SITE ADDRESS
LONDIS - GRANGE LANE
94A GRANGE LANE,
BARNSELY,
S71 5QQ

TITLE
PROPOSED AUTOMATED TELLER MACHINE (ATM)
INSTALLATION FOR CASHZONE
DRAWN MAL DATE 24/10/25 SCALE VARIOUS @A3
REF/DRG No. E029914 SHEET REVISION 02

PROPOSED (PART) PLAN

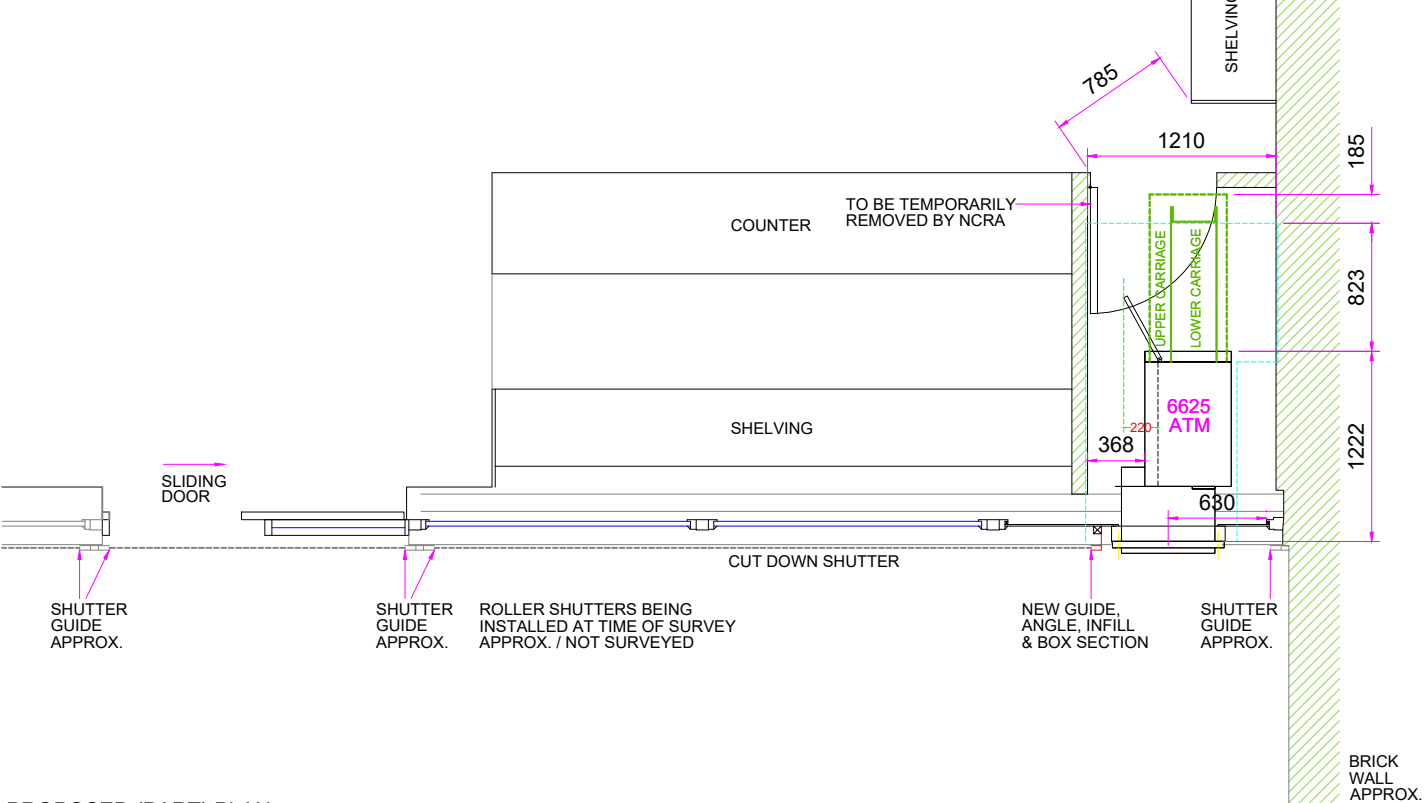
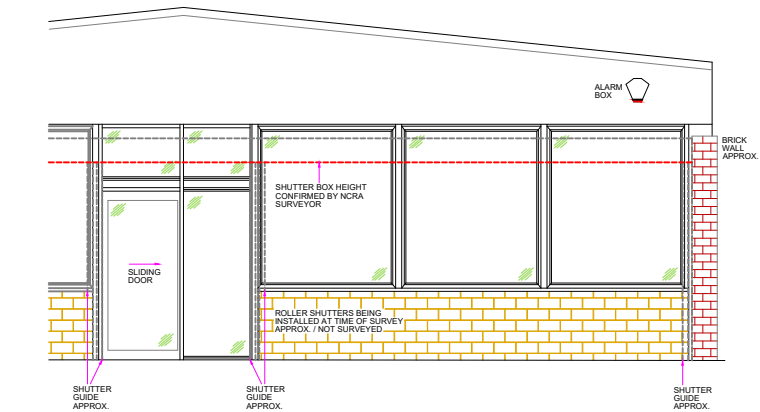
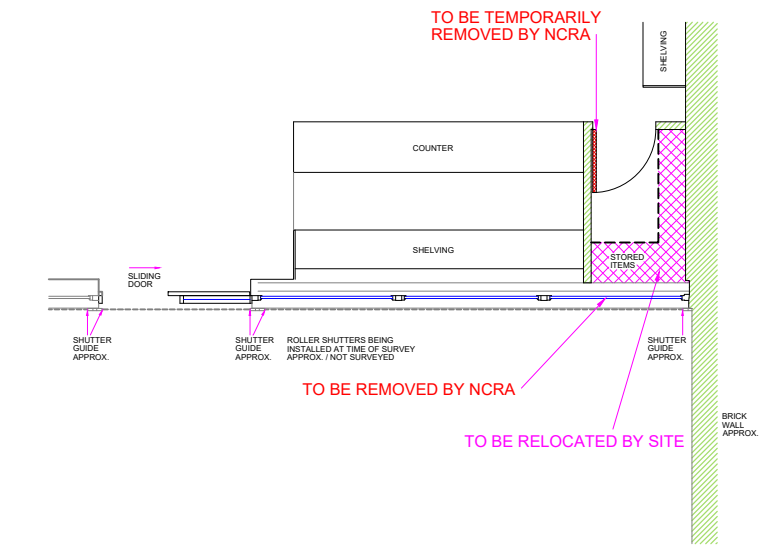
04			
03			
02	SHUTTER GUIDE RAIL MOVED CLOSER TO THE ATM AS FIT	16/06/26	CT
01	ATM TYPE CHANGED FROM 6625 ADV BEZEL TO 6625 STD BEZEL DUE TO AVAILABILITY.	19/01/26	MAL
REVISION	DESCRIPTION	DATE	BY

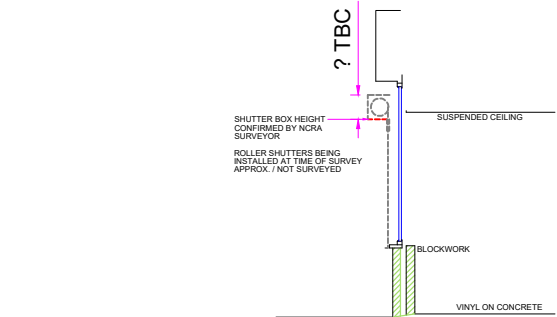
MODIFY / CUT DOWN SHUTTER - NEW GUIDE, ANGLE, INFILL AND BOX SECTION REQUIRED (WORKS TBC SUBJECT TO SHUTTER SURVEY)
